April 14, 2010

During the second comment period for the proposed 2011 ENERGY STAR New Homes guidelines, EPA received over 140 pages of comments from respondents. EPA has reviewed all comments and has greatly refined the guidelines in response. This document provides a summary of the most significant changes, but omits many smaller changes that were made, such as minor clarifications and the addition of formal definitions. For more information, please see the revised guideline documents and EPA's detailed response document, which contains all policy changes made and the accompanying rationale.

Exhibit 1: ENERGY STAR New Homes Version 3.0 Implementation Schedule

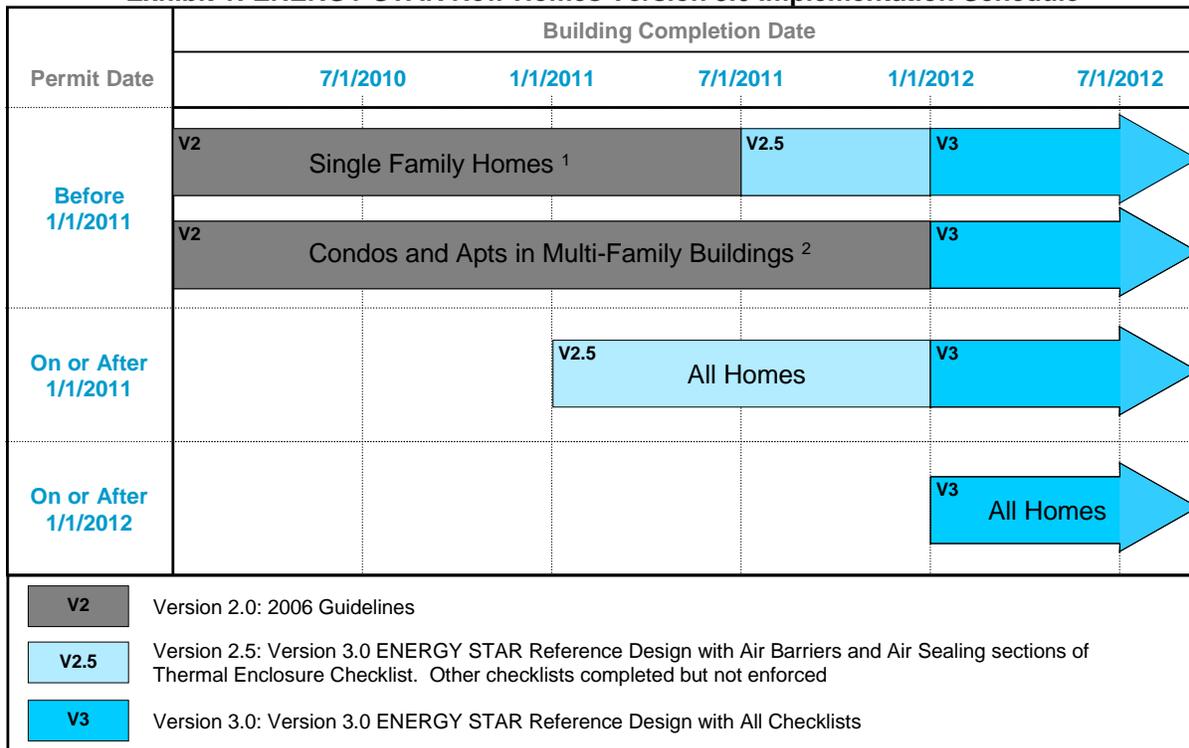
EPA has modified the implementation timeline by allowing additional time for multi-family buildings to transition to the version 3.0 requirements. Furthermore, it has clarified that some homes may use a transitional version of the guidelines during the 2011 calendar year, named v2.5, which is composed of the version 3.0 ENERGY STAR Reference Design coupled with the Air Barriers and Air Sealing sections of Thermal Enclosure Checklist. Under this version 2.5, the other inspection checklists shall be completed but not enforced. The revised implementation timeline is illustrated in Exhibit 1.
